Addendum #2

Project Name: Nebraska Innovation Campus - 4H Building Renovation & NIC Office Building.
Project No.: 11053
Issued: November 13, 2012
Bid Date: Tuesday, November 20th, 2012
Bid Opening: 2:00pm – Private Opening
Location: 728 Q Street Suite C, Lincoln, NE 68508

Attachment: S16
Reference: 10/S504CD
Bid Package: 02
Addendum: 02

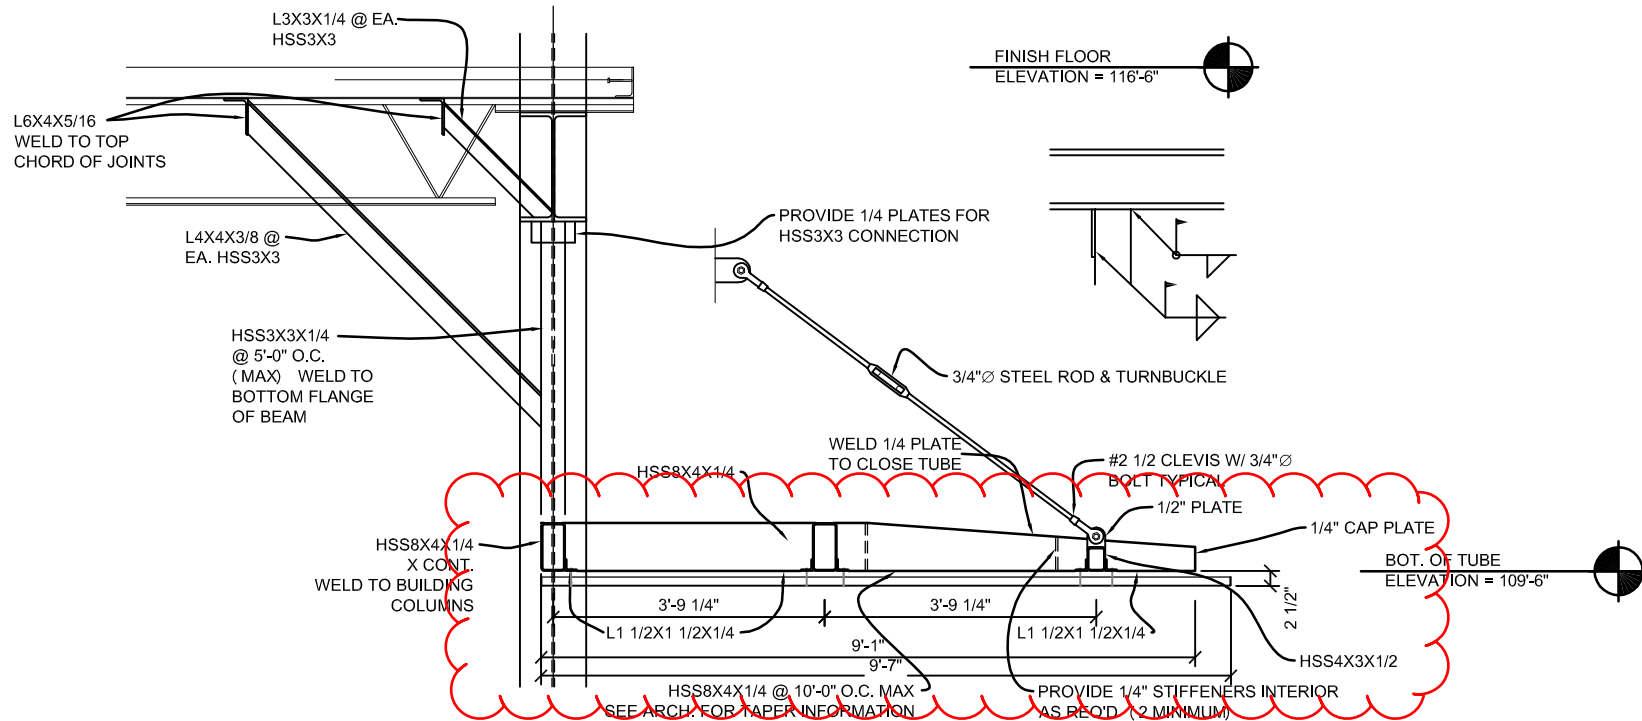
- a. See attached Sketch S11. Note revisions to the detail for connecting the beam to the column.
- b. See attached Sketch S12. Note additional information (grate note, detail mark) added to the detail and revisions to the dimensions. The sketch is on 11x17 paper and was plotted to fit on the 11x17 paper.
- c. See attached Sketch S16. Note dimension revisions and revisions to beam size.

Attachment: S7
 Reference: 5/S304CD
 Bid Package: 02
 Addendum: 02

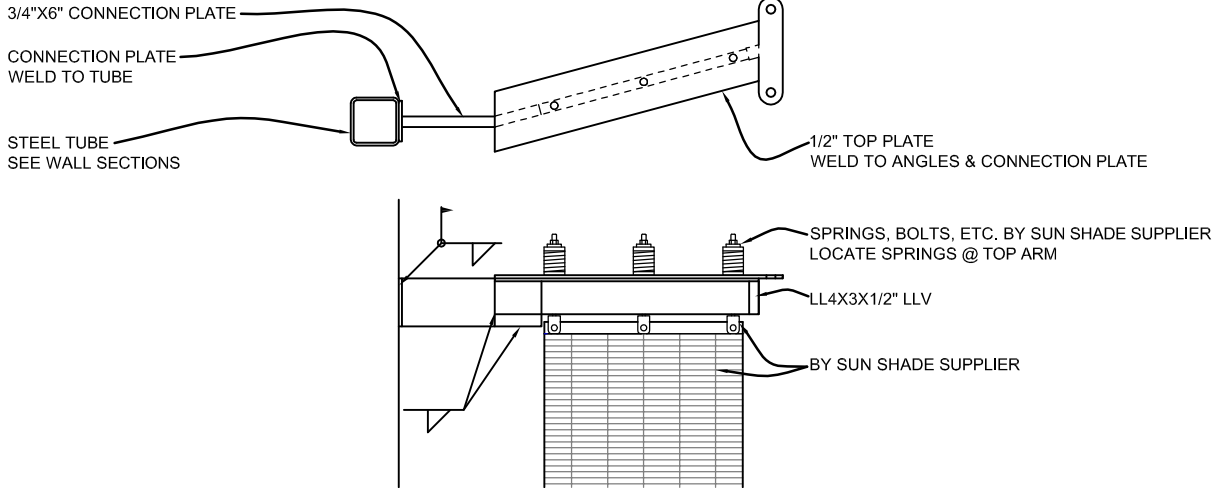
- a. See attached Sketch S7. Note revisions to detail. See architectural for more information.

Attachment: ES101.2
 Reference: 1/ES101
 Bid Package 02
 Addendum 02

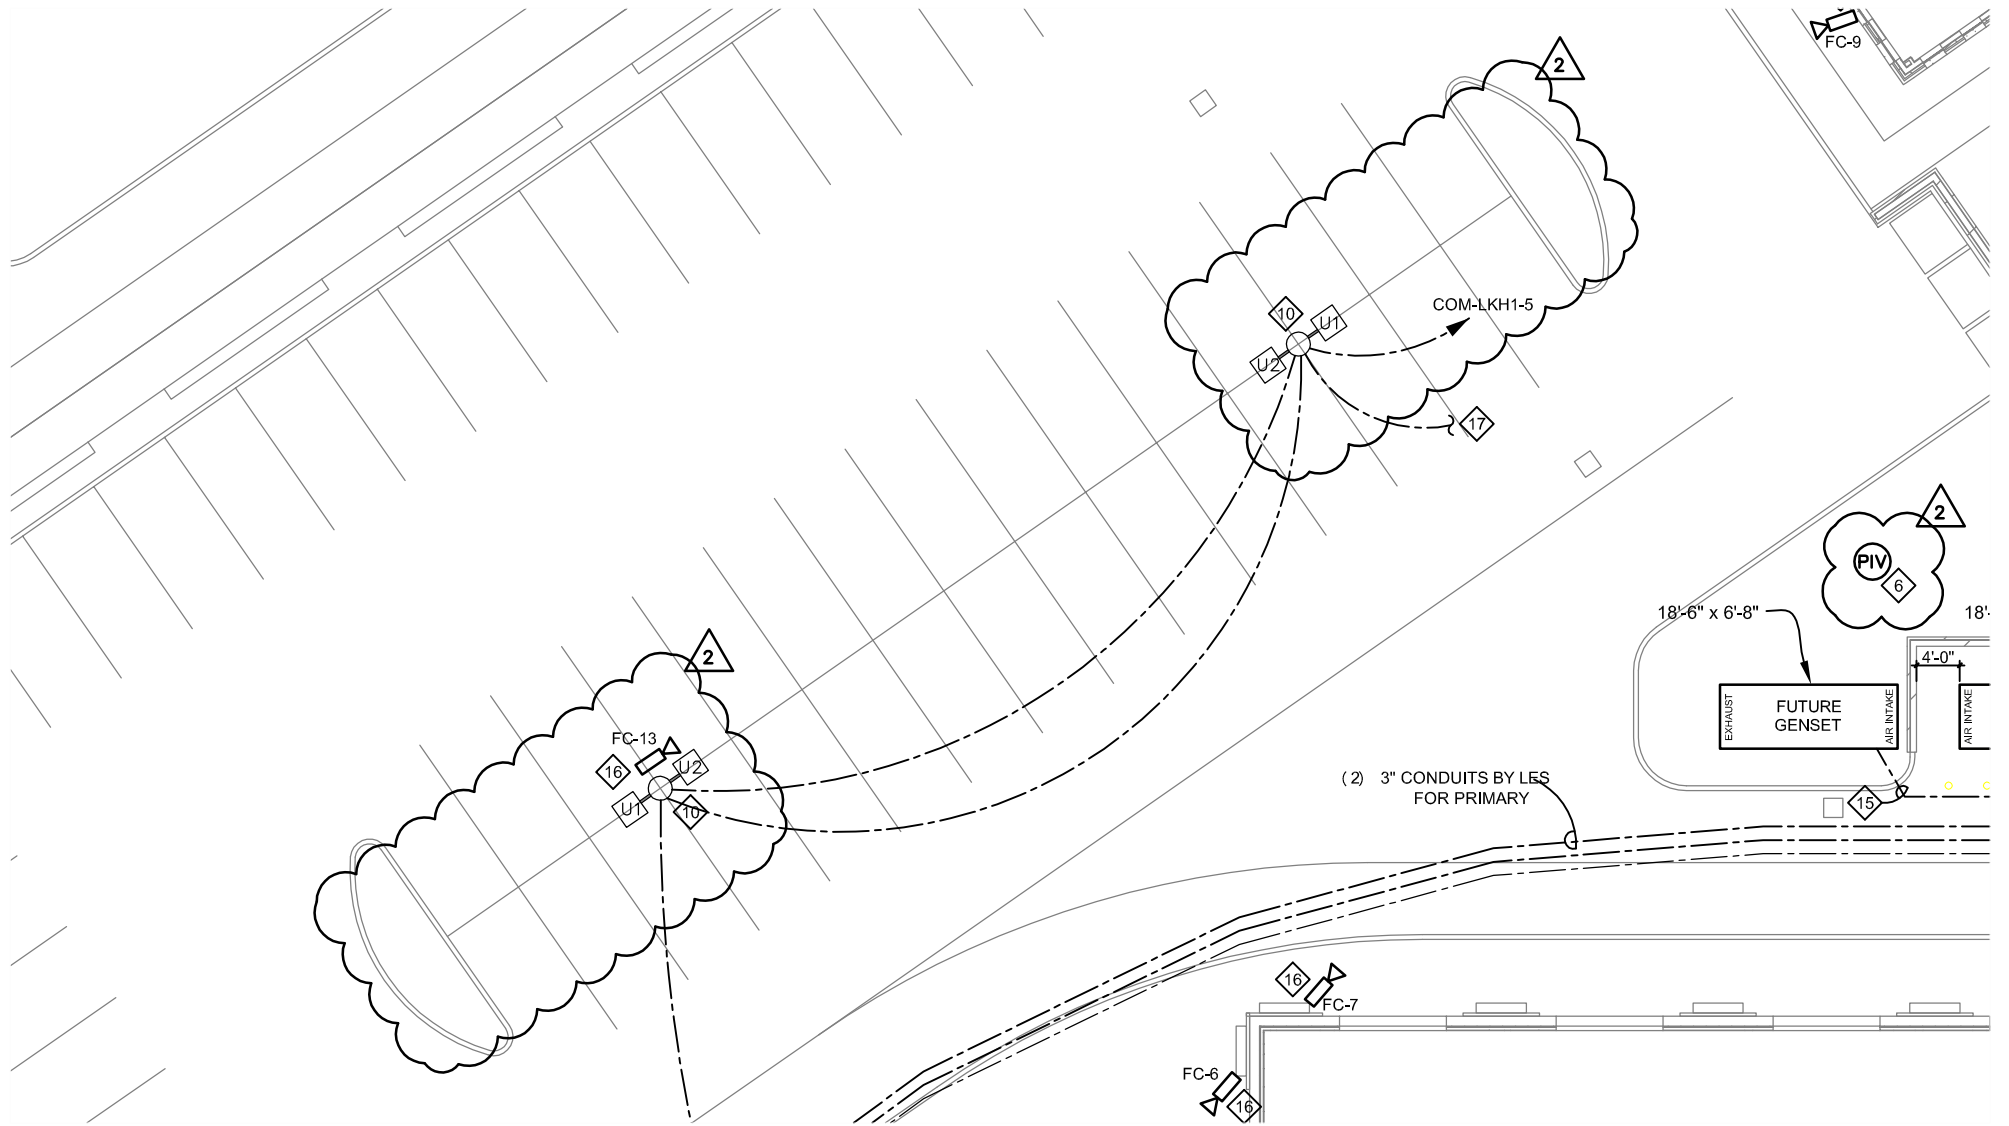
- a. Refer to Plan 1; see **Attachment ES101.2** for revised plan view showing adjusted light pole locations in the parking lot and the revised PIV location near the generator.
